Stage 1 Road Safety Audit

**R194 Longford Road Pedestrian Improvements
Scheme, Granard, Co. Longford.**

On behalf of Longford County Council

3.2.4 Zebra Crossing – Location

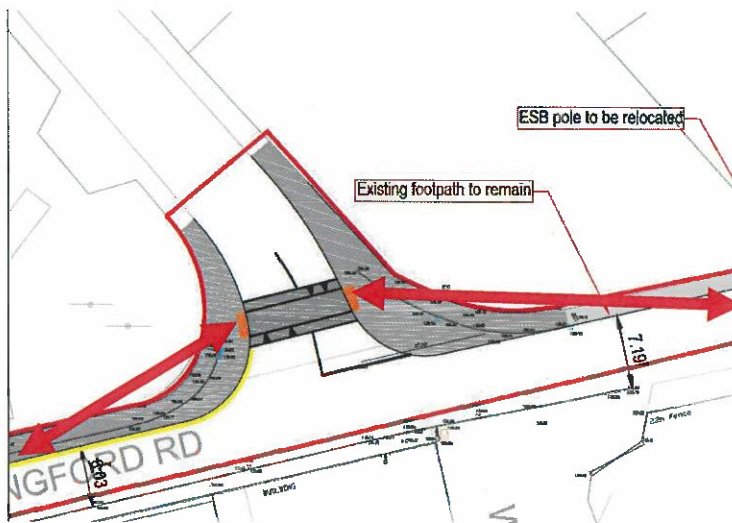
Problem: The widened footpath leading to/from the zebra crossing is located to the west of the Pat the Baker development. Pedestrians are likely to walk via the widened footpath and be required to cross the development junction(s).

Hazard: Pedestrians may be struck by development traffic entering/exit the facility.

Recommendation: Relocate the zebra crossing to the east of the development and widen the southern footpath.

3.2.1	Yes	Yes		
3.2.2	Yes	Yes		
3.2.3	Yes	Yes		
3.2.4	Yes	No	Widening the southern footpath is not possible due to existing parking demand.	Yes
3.3.1	Yes	Yes

3.3.2 Pat the Baker – HGV Yard

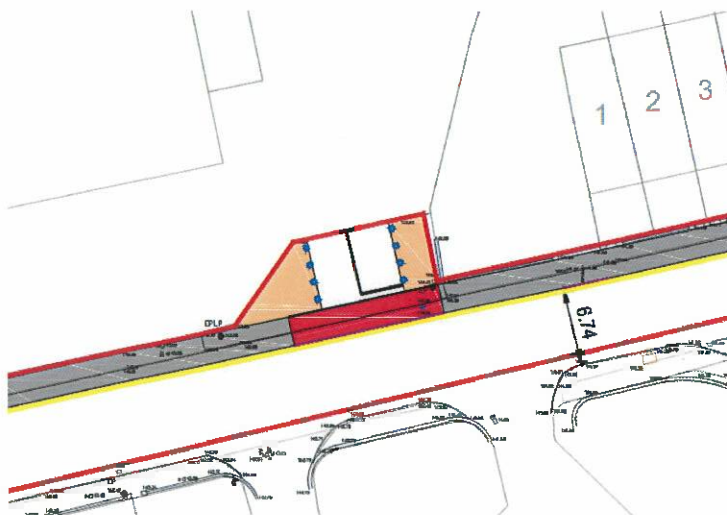
Problem: HGV drivers exiting have poor visibility for pedestrians approaching from the left.

Hazard: Pedestrian strikes may occur.

Recommendation: Improve visibility for exiting HGV drivers. Providing bollard(s) to distance the HGVs from the left exit corner may give the drivers improved visibility.

3.3.2	Yes	Yes	Provision of bollards may impede exiting left turning HGVs. Hatching will be provided instead of bollards.	
3.3.3	No	No	There is 7.0m clearance between the proposed bollards, this is considered easy passage for two-way traffic.	Yes

3.3.4 Zebra Crossing – Dwelling Entrance.

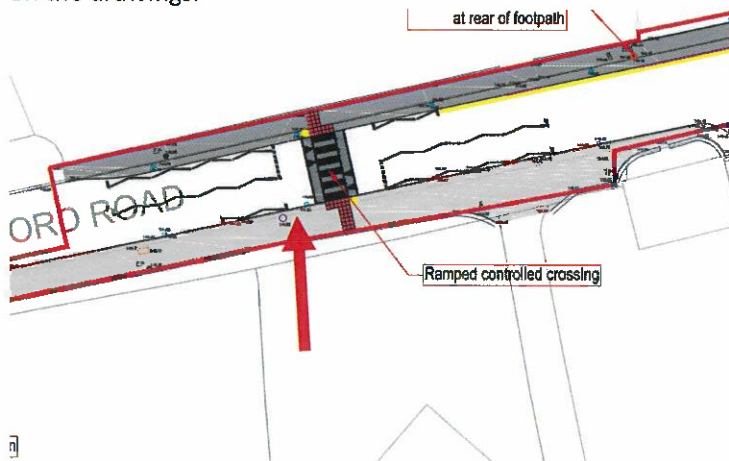
Problem: There is a dwelling driveway close to the proposed zebra crossing location that is not shown on the drawings.

Hazard: There is concern that vehicles entering / exiting the driveway may impact with pedestrian at the crossing.

Recommendation: Survey the driveway and ensure there is sufficient separation between the zebra crossing and the driveway.

3.3.4	Yes	Yes		
3.3.5	Yes	Yes		
3.3.6	Yes	Yes		
3.3.7	Yes	Yes		
3.3.8	Yes	No	Dropped kerb will be provided. As no works are proposed on the northern footpath at this location and there is no existing blister in the path, no blister tactile paving will be installed with the dropped kerb on the southern footpath	Yes

3.3.5 Zebra Crossing – Street Lighting.

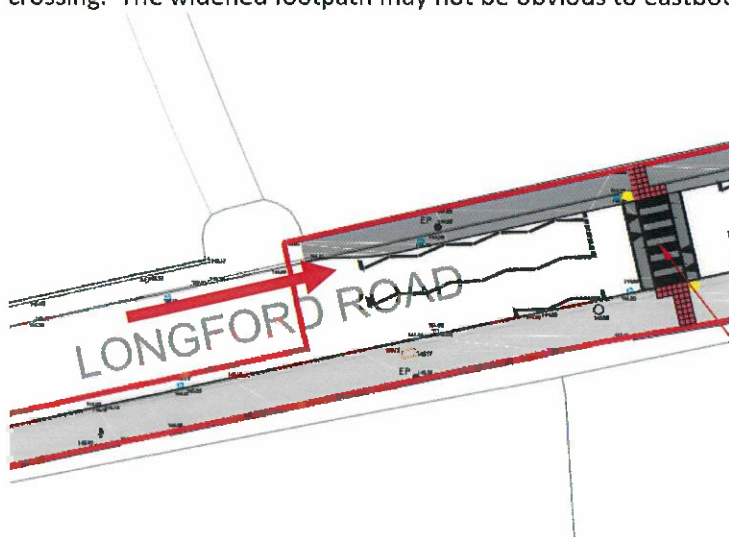
Problem: The proposed zebra crossing is located approximately midway between the existing street lights. There is concern that the zebra crossing will not have the same level of illumination as the adjacent roadway.

Hazard: Pedestrians on the crossing may be inconspicuous and susceptible to vehicle strikes.

Recommendation: Provide additional street lighting at the crossing location.

3.3.7 Road to the East of Ardscoil Phadraig

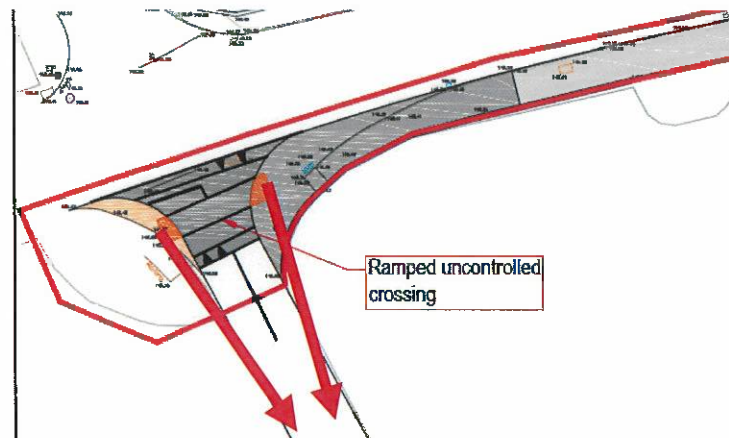
Problem: There is a proposed raised uncontrolled pedestrian crossing of the road to the east of Ardscoil Phadraig. Pedestrian visibility to the south from the crossing is restricted by boundary walls and vegetation, the crossing is also angled towards the barrier at the school entrance.

Hazard: Pedestrians may commence their crossing and be subject to vehicle strikes. Sight impaired pedestrians crossing may be guided into the barrier at the school entrance.

Recommendation: Relocate the crossing closer to Longford road, where improved visibility can be achieved and also sight impaired pedestrians will be guided onto the footpath continuing past the school barrier.

3.3.8 Dropped Kerb at Junction of Longford Road with L5128

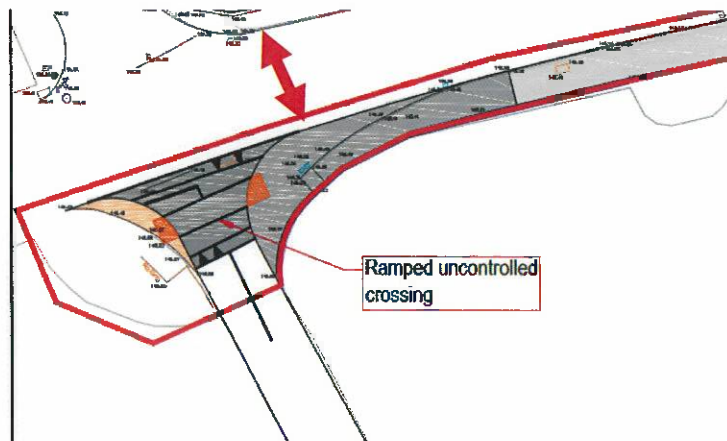
Problem: There is an existing dropped kerb to the northern side of Longford Road near the junction with the L5128. Presently pedestrian can cross north-south from this dropped kerb to the far side of the road with no trip hazards. Upon completion of the proposed works and new full face kerb will need to be negotiated.

Hazard: Mobility impaired pedestrians may trip/fall due to the high kerb.

Recommendation: Provide dropped kerbs, complete with blister tactile paving to both sides of the Longford Road.
